**ADDENDUM
NO. 05**

Renovation of Fall Creek Intermediate School
12011 Olio Road
Fishers, IN 46038

Addendum #5
Hamilton Southeastern School Corporation
Fall Creek Intermediate Renovations

Date: August 19, 2024
Project: FCI – Renovations
Project #: 23055
Pages: 1 of 1
Bid Dates: **August 22, 2024**

M4-3 – ENLARGED MECHANICAL PLANS

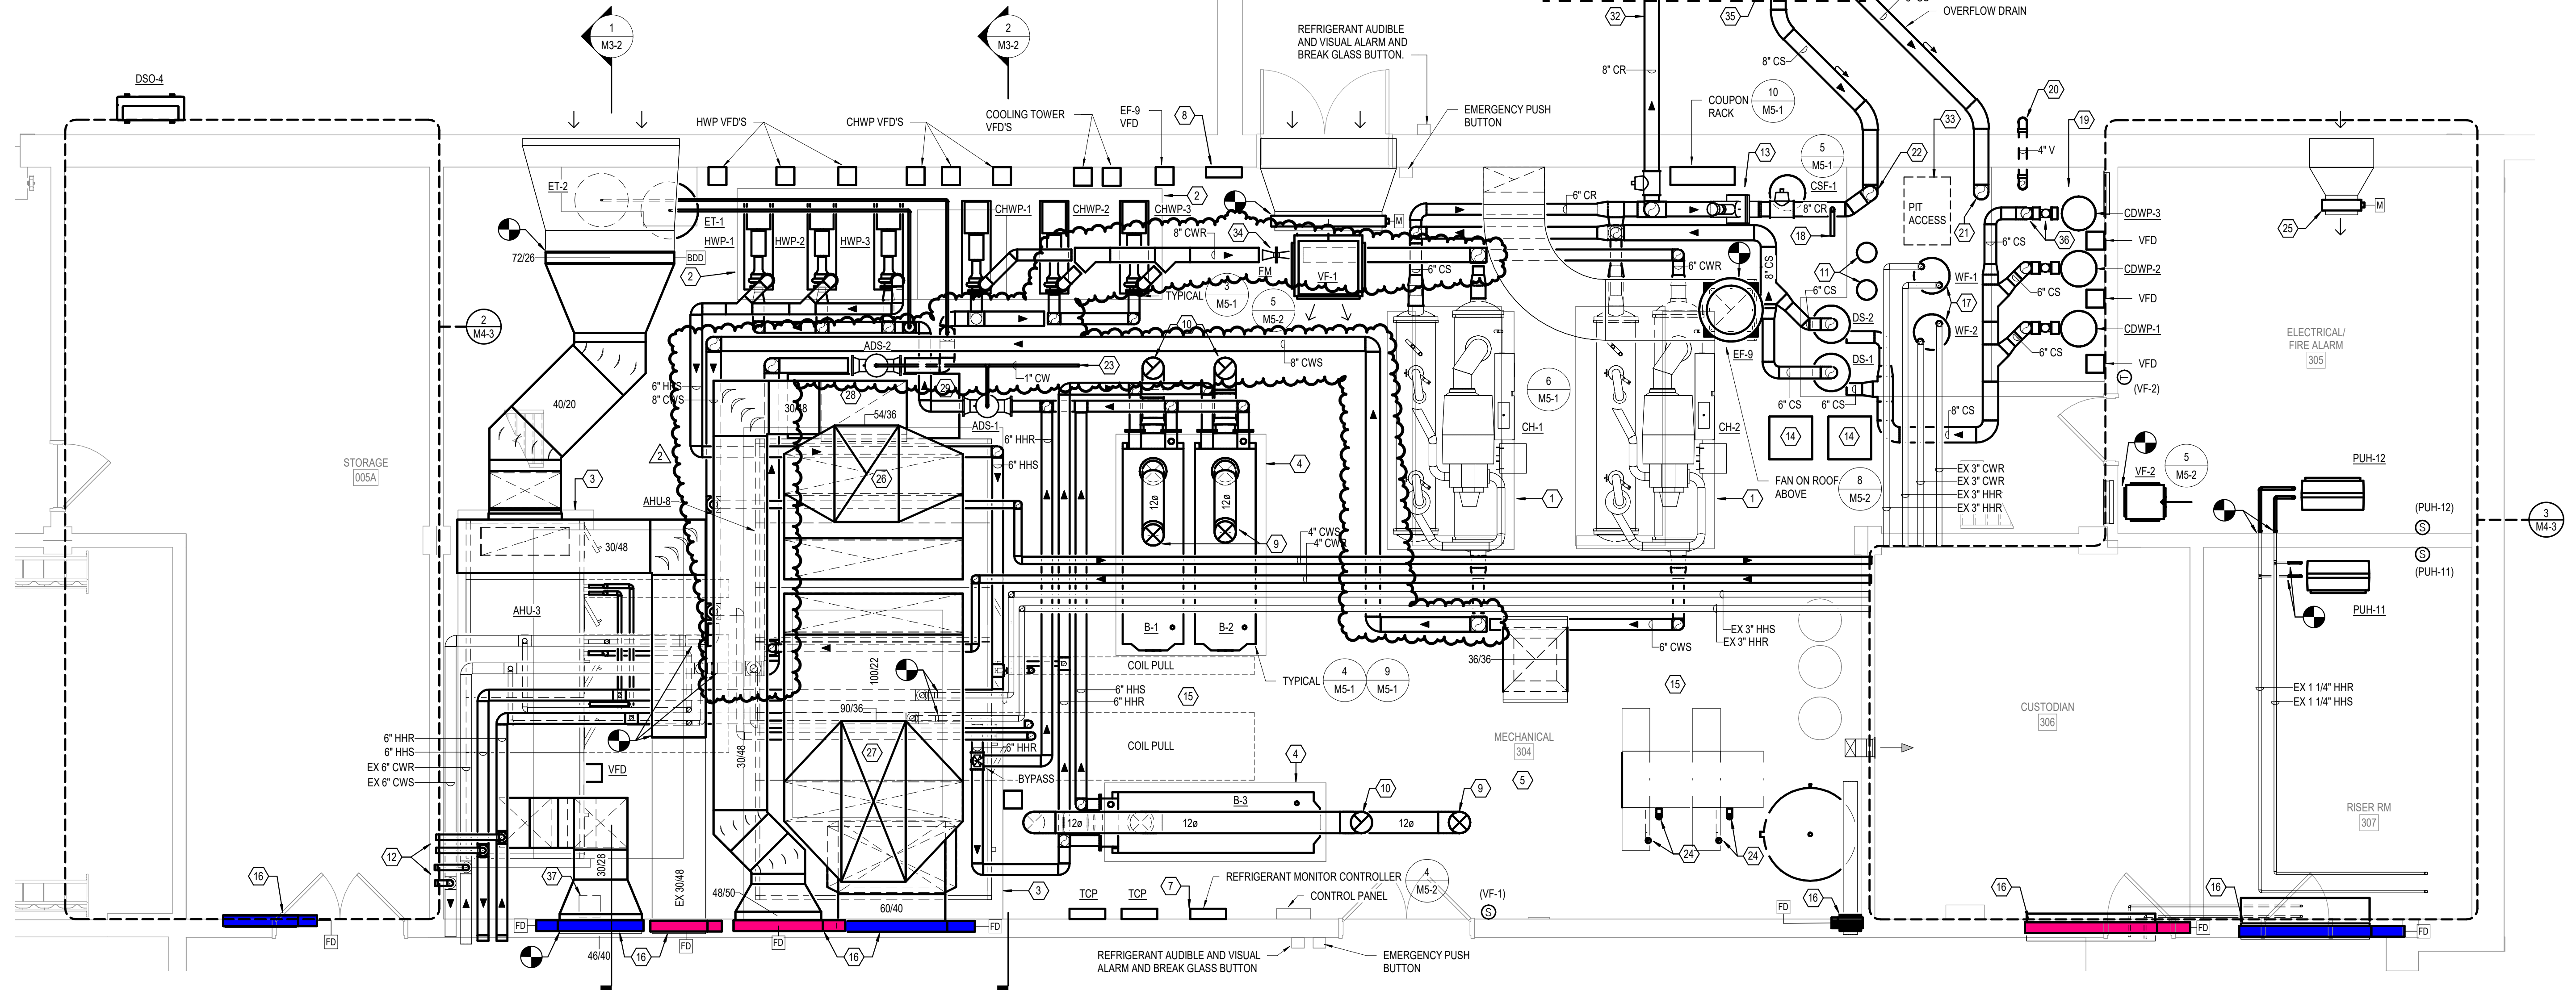
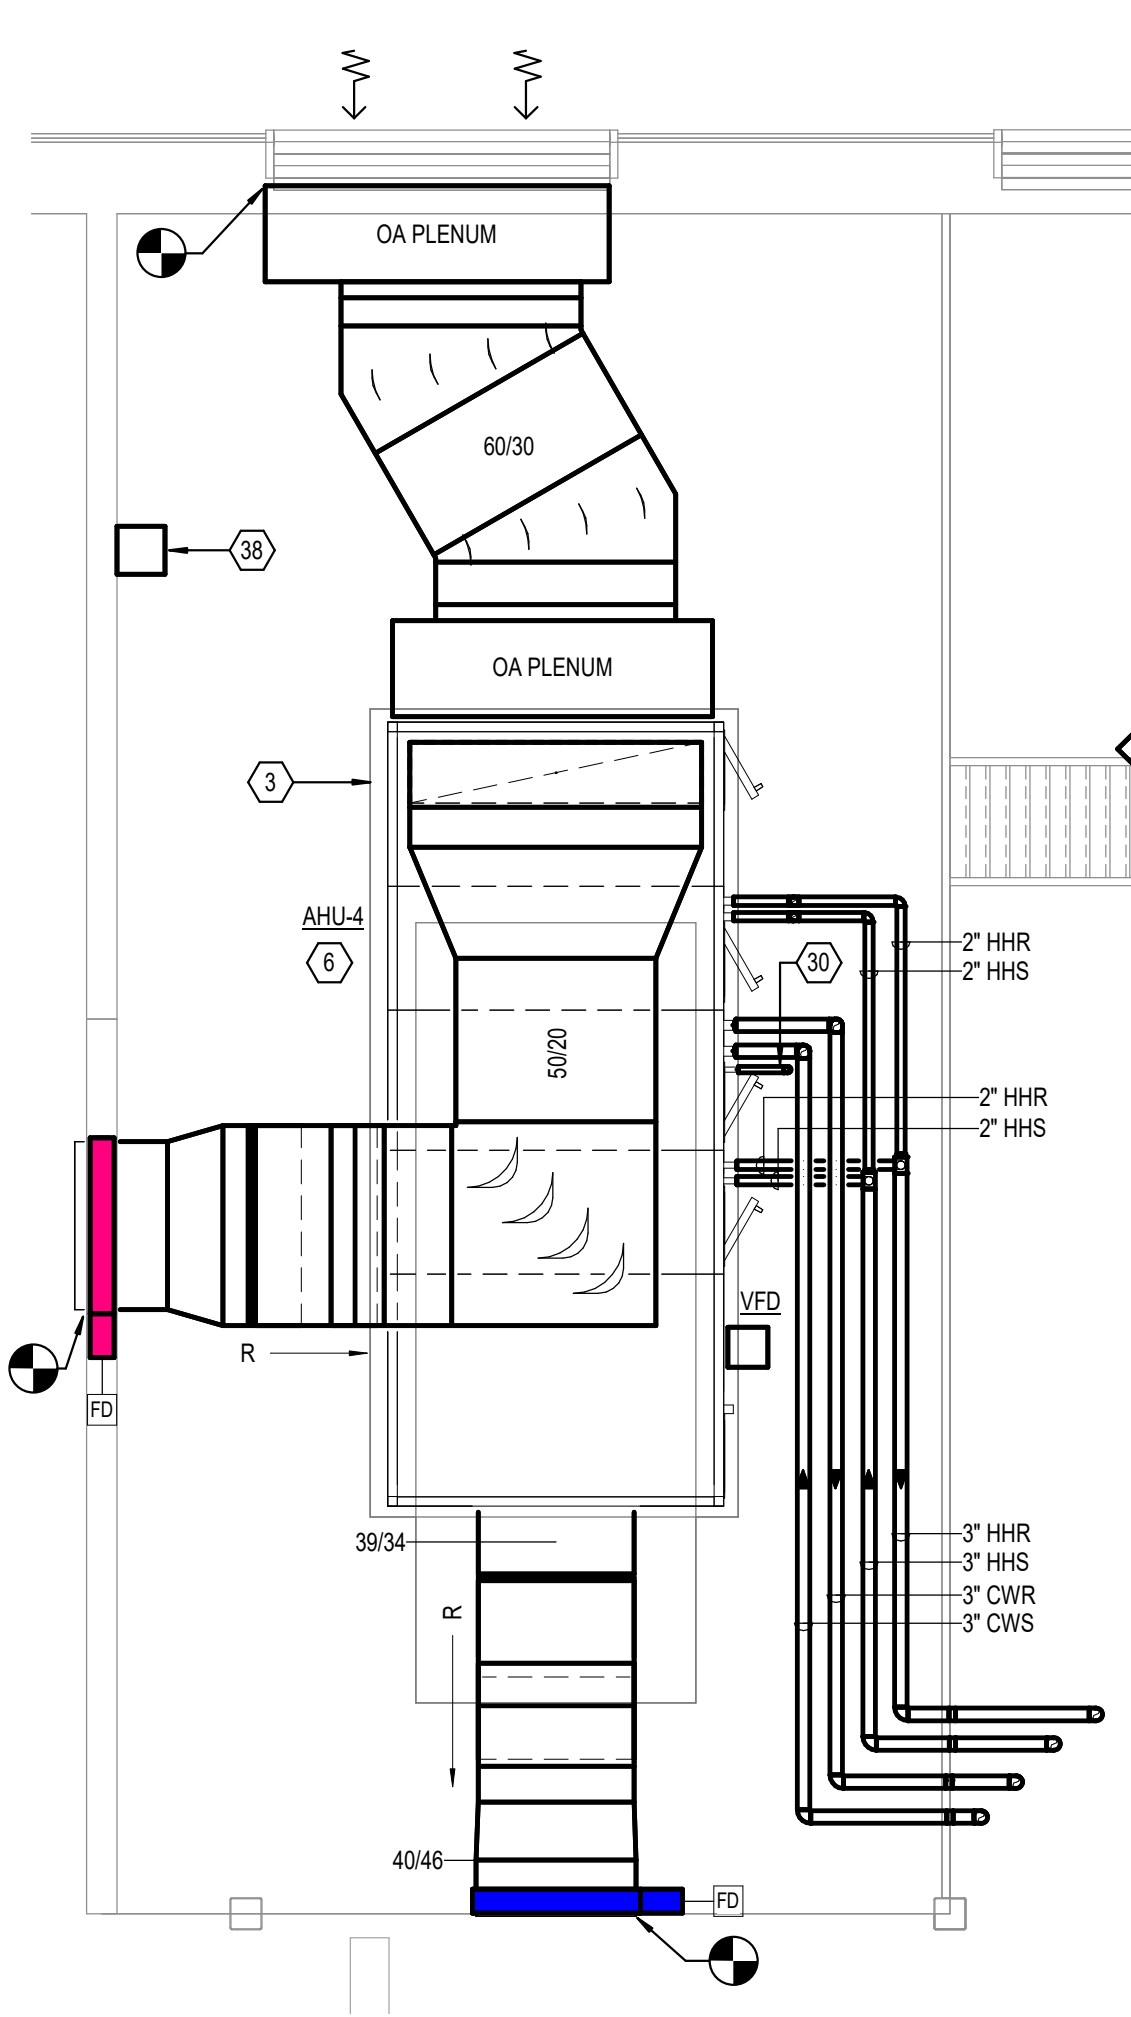
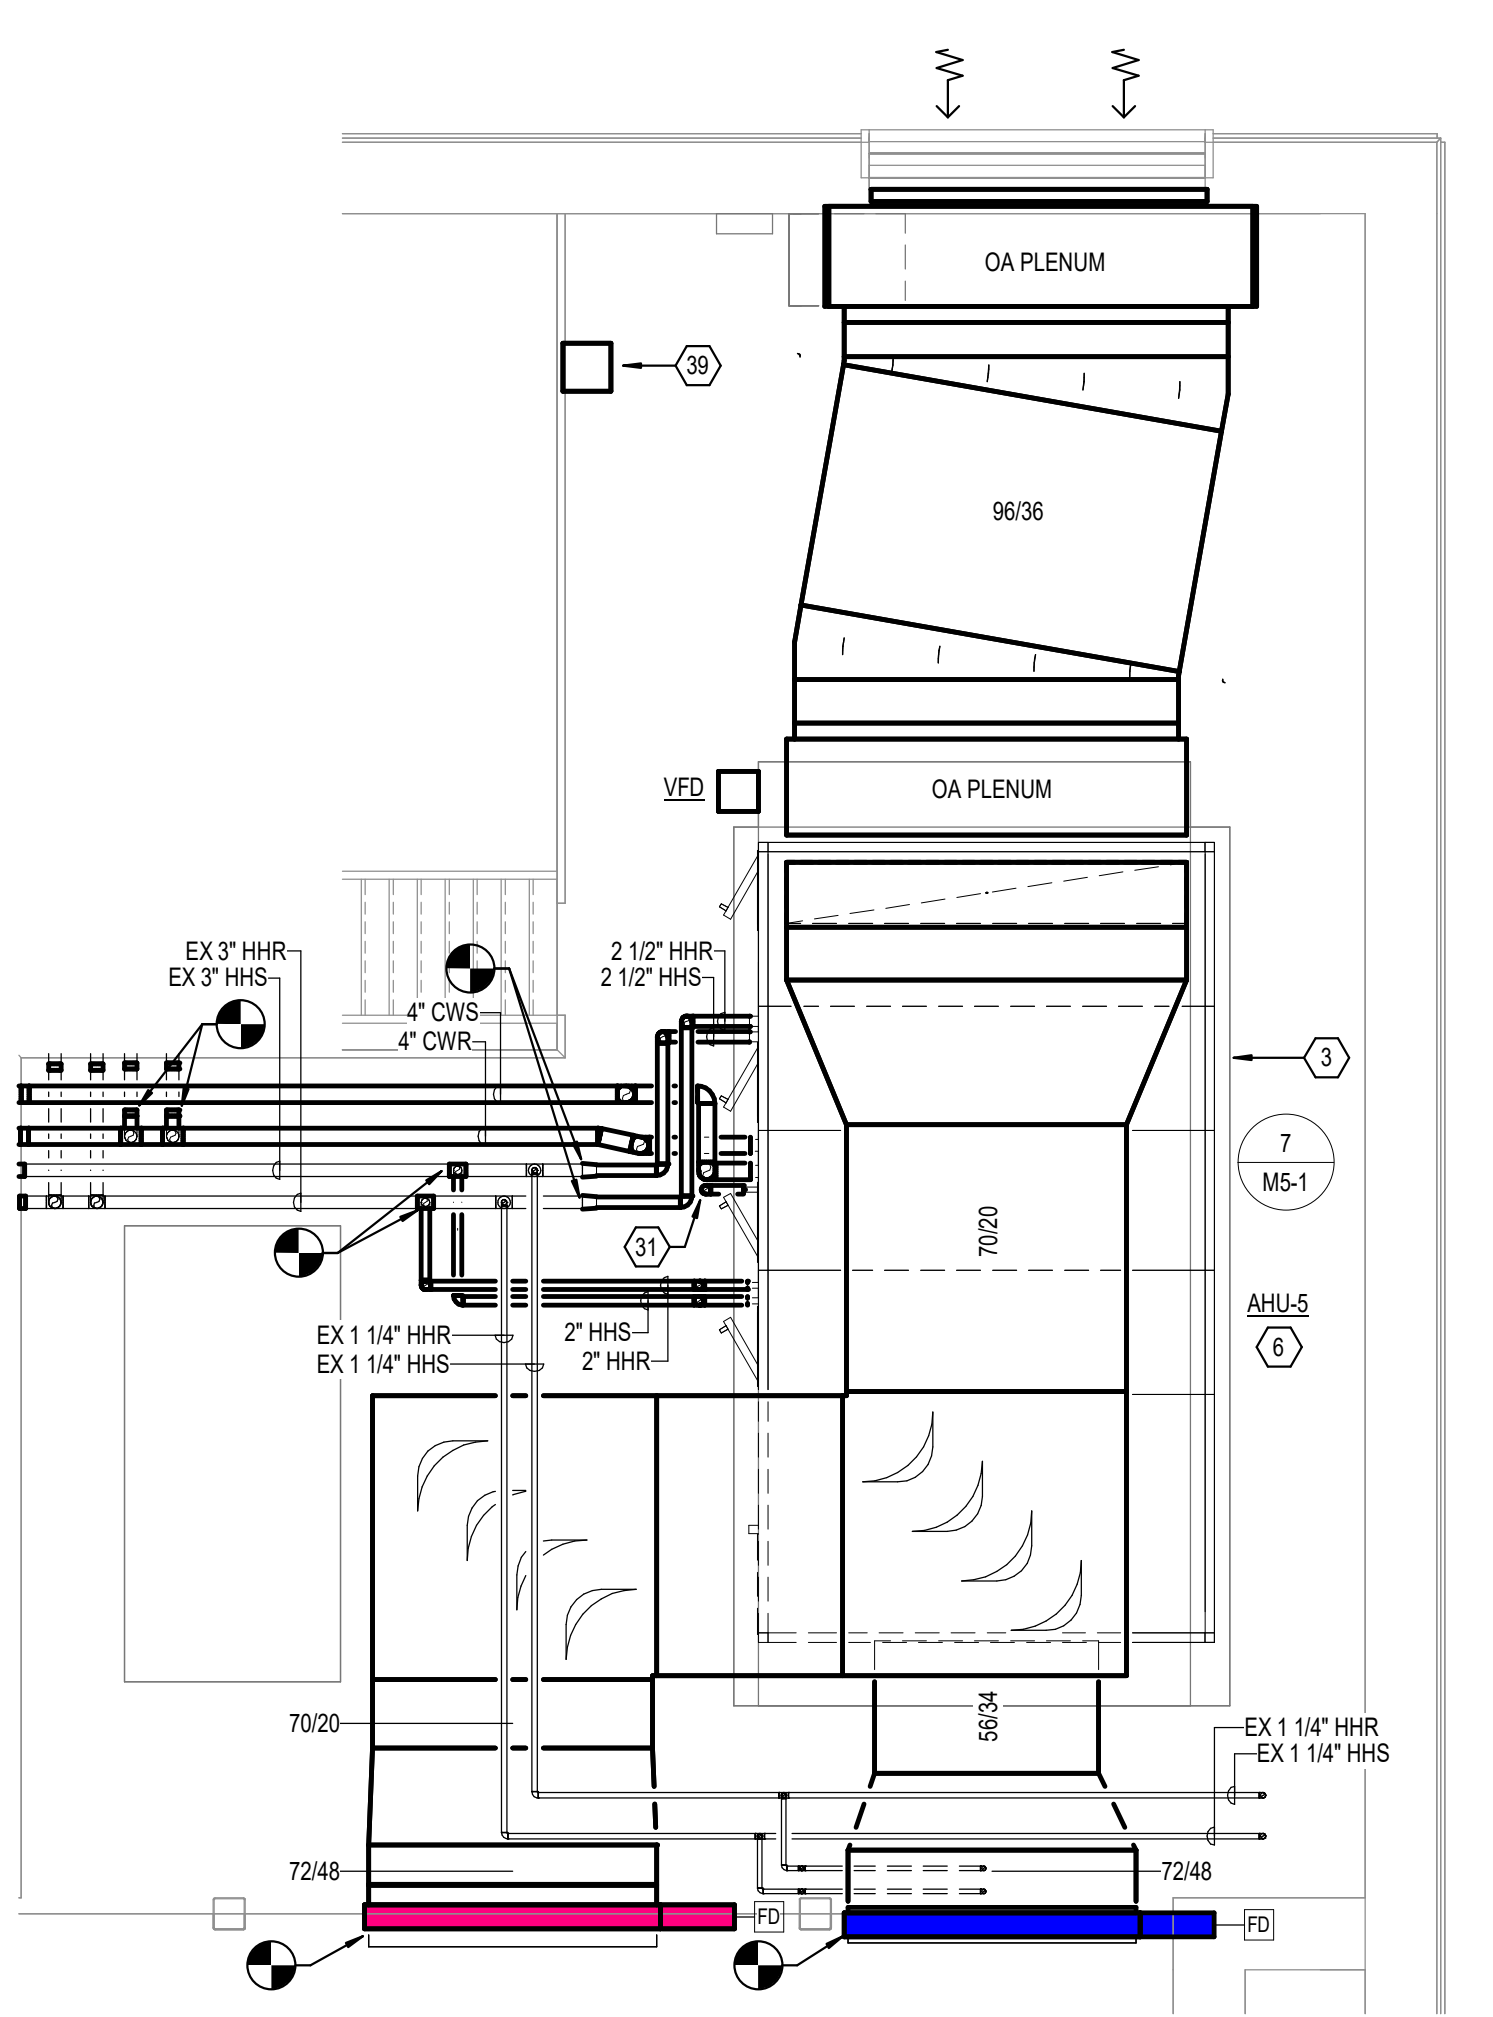
1. Revised Chilled water piping size from 6” to 8”

M4-4 – ENLARGED MECHANICAL PLANS

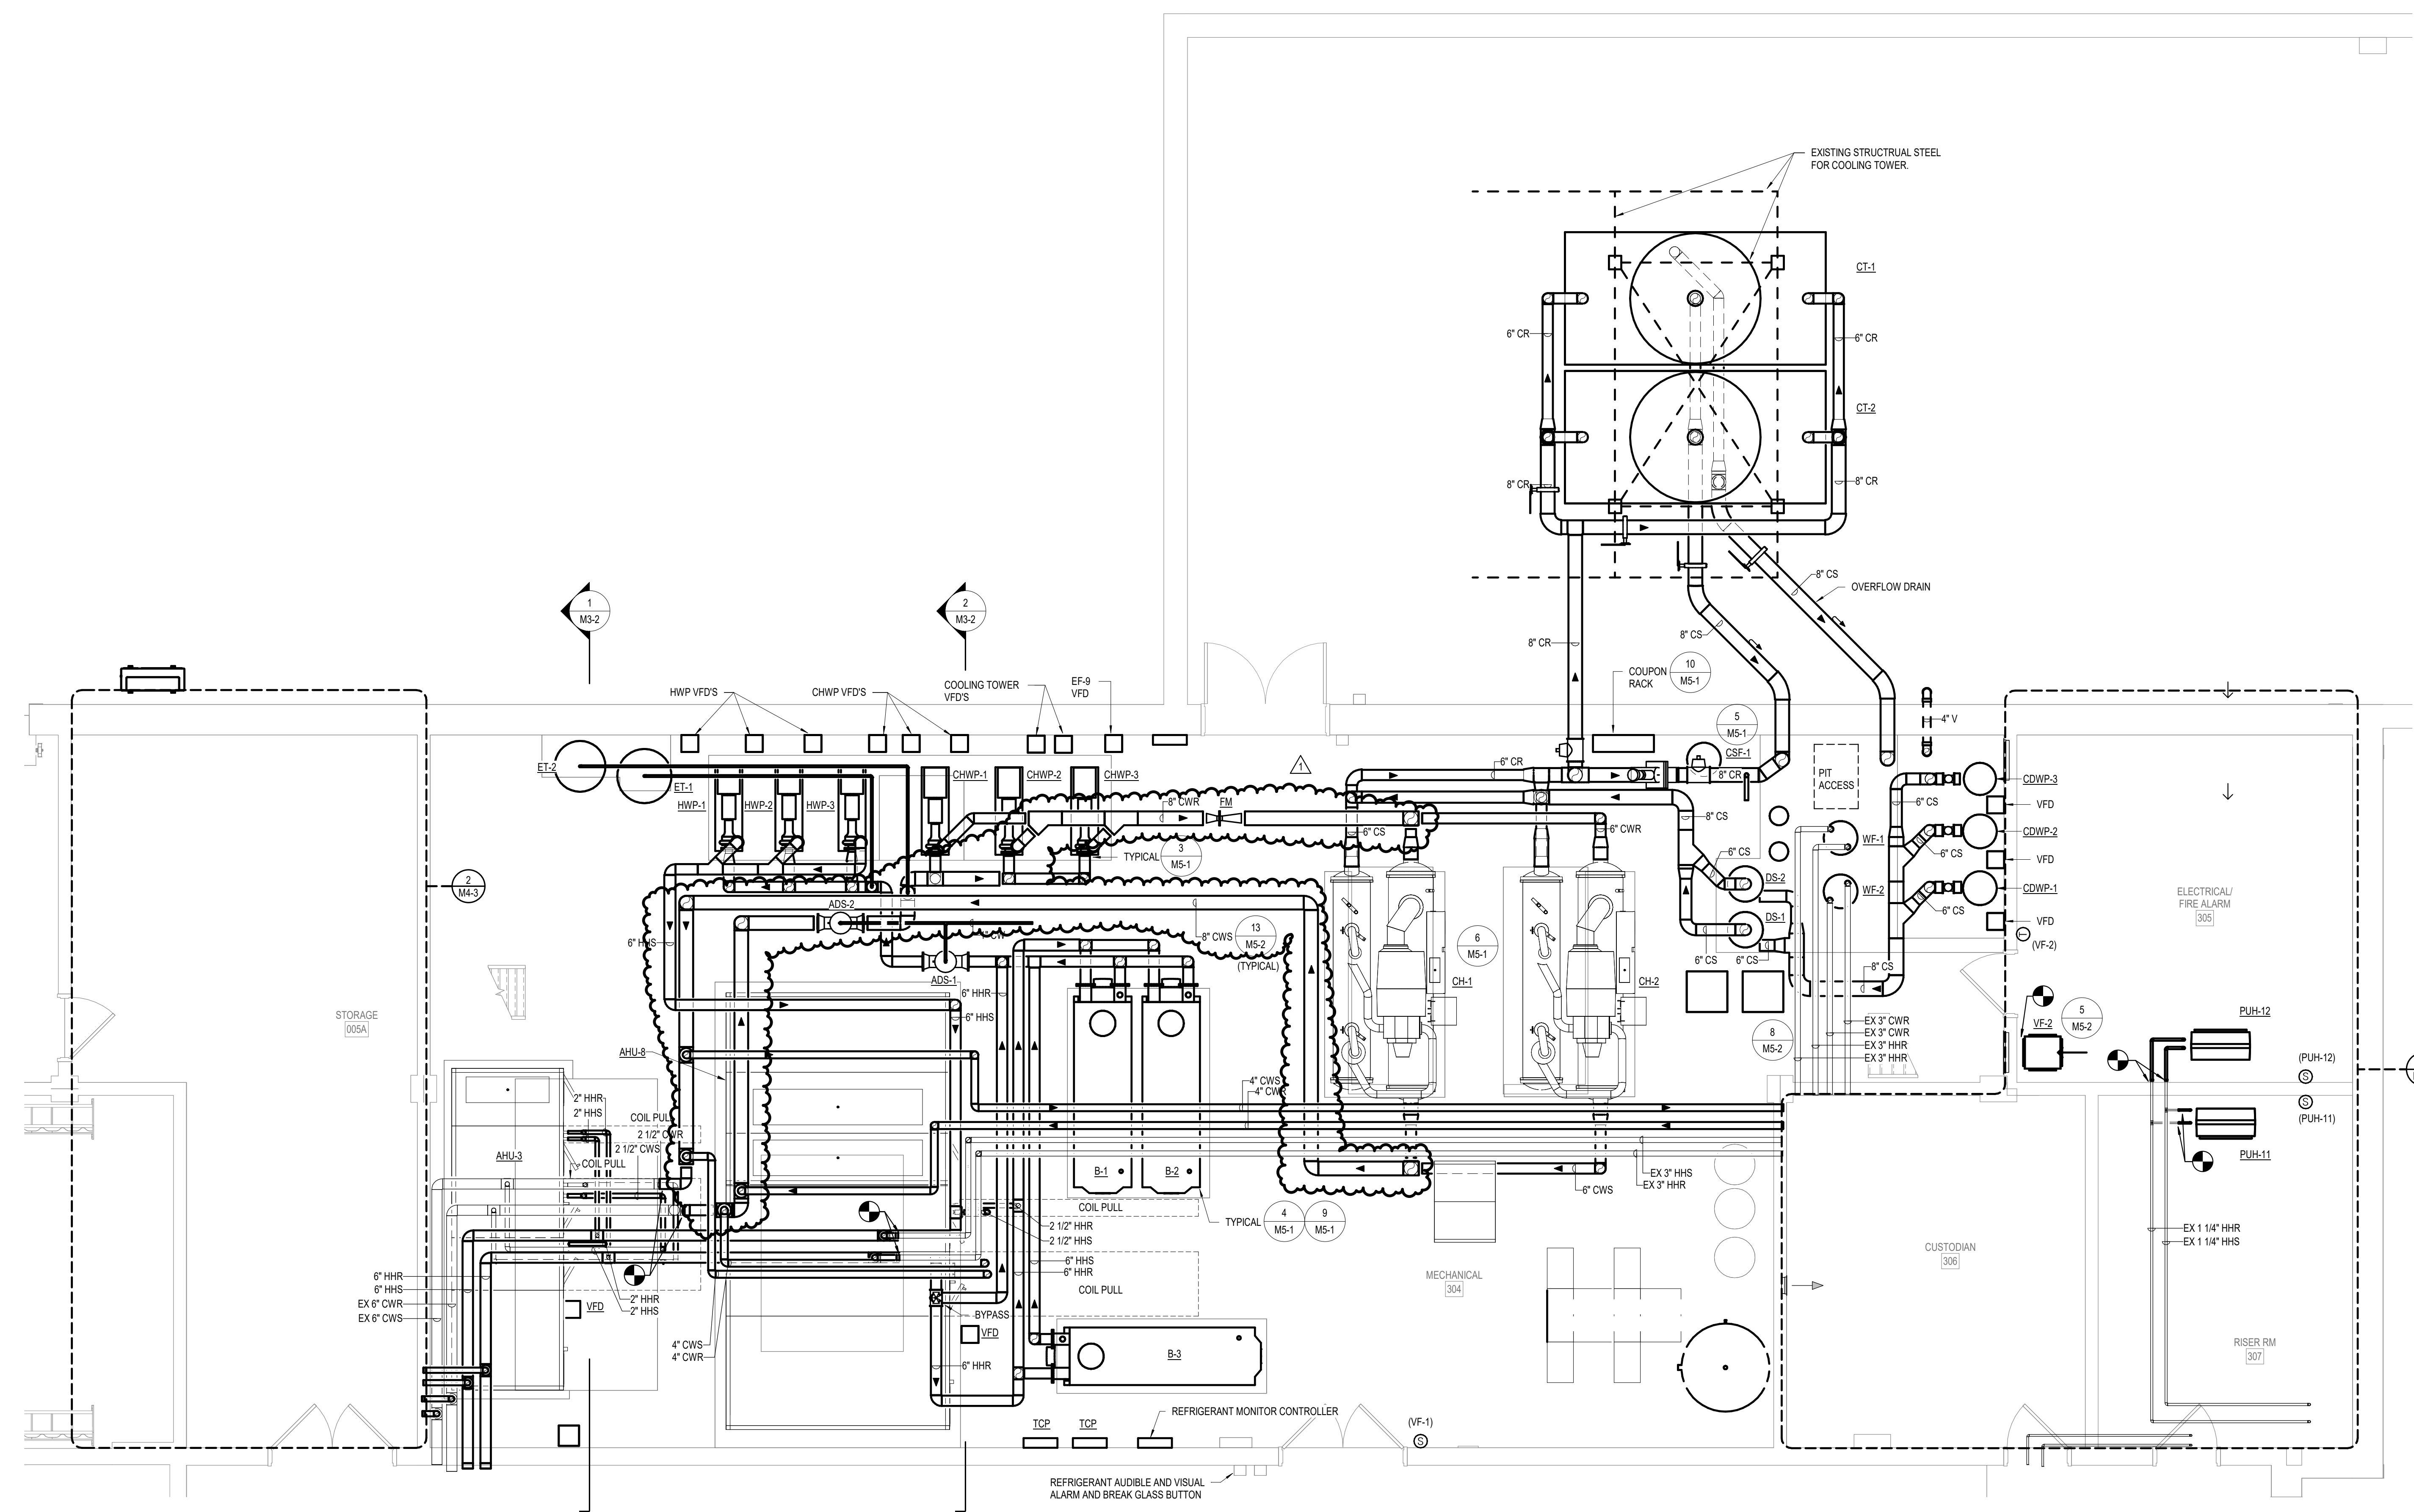
2. Revised Chilled water piping size from 6” to 8”
